# Proposed Revisions DBNGP Access Arrangement

*2016 – 2020 Regulatory Period  
Supporting Submission: 53*

*DBP Transmission (DBP) is the owner and operator of the Dampier to Bunbury Natural Gas Pipeline (DBNGP), Western Australia's most important piece of energy infrastructure.*

**Figure 1: Maturity of DBP's Project Management Methodology framework as identified in the audit report**

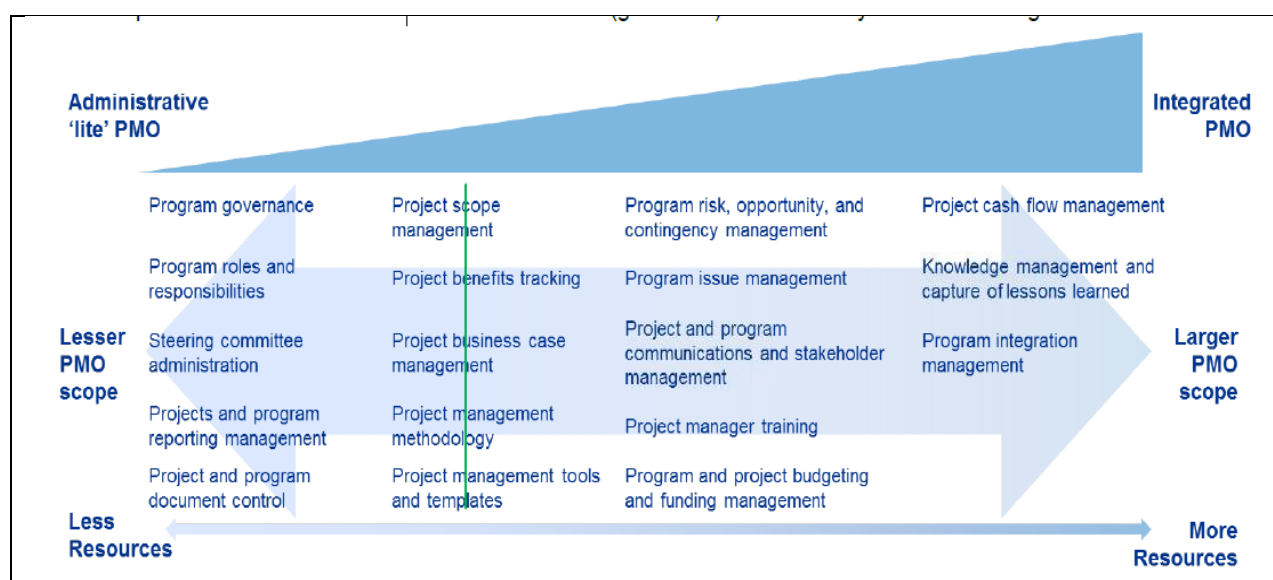
- 7.14 Accordingly, during AA3, DBP was not only implementing this new framework but it was endeavouring to deal with the teething issues associated with implementing any new system. The recent audit of the framework identified that the maturity of the PMM sits near the green line in the figure below.

- 7.15 DBP recognises that not all of the documentation required by the PMM are produced in practice which has contributed to some of the issues outlined by EMCa. Since the implementation of the PMM framework, DBP has been continually refining the framework to ensure that the system is designed and recognised as improving the efficiency and prudence of managing and implementing projects. In light of this, it would be unreasonable to conclude that the non compliances with the PMM are evidence of systemic failings to such an extent that the expenditure is inefficient and imprudent. The issues are of a result of the unavailability of discrete documents and not as a result of the unavailability of the information.

**Figure 2: Comparison of AA3 reactive maintenance – actuals v forecast (\$m)**

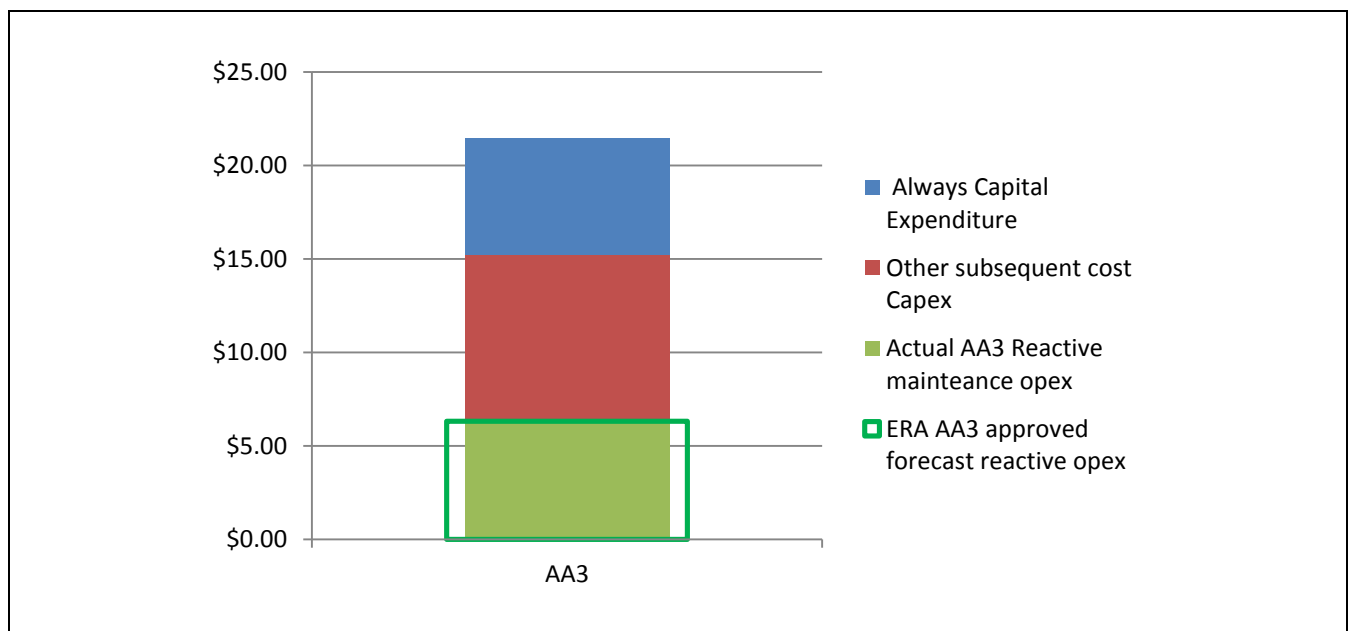
- 10.21 The following figure shows the total expenditure actually incurred by DBP for reactive (ie unplanned) maintenance and repair of turbines during AA3 split between Turbine Reactive Maintenance Expenditure in the SIB capex category and Reactive Maintenance Opex category, compared with the forecast allowance in AA3 for forecast reactive maintenance operating expenditure. It also includes the items of AA3 SIB Subsequent Cost Capex that DBP has identified as "Always Capital Expenditure"

10.22 In summary, it shows that:
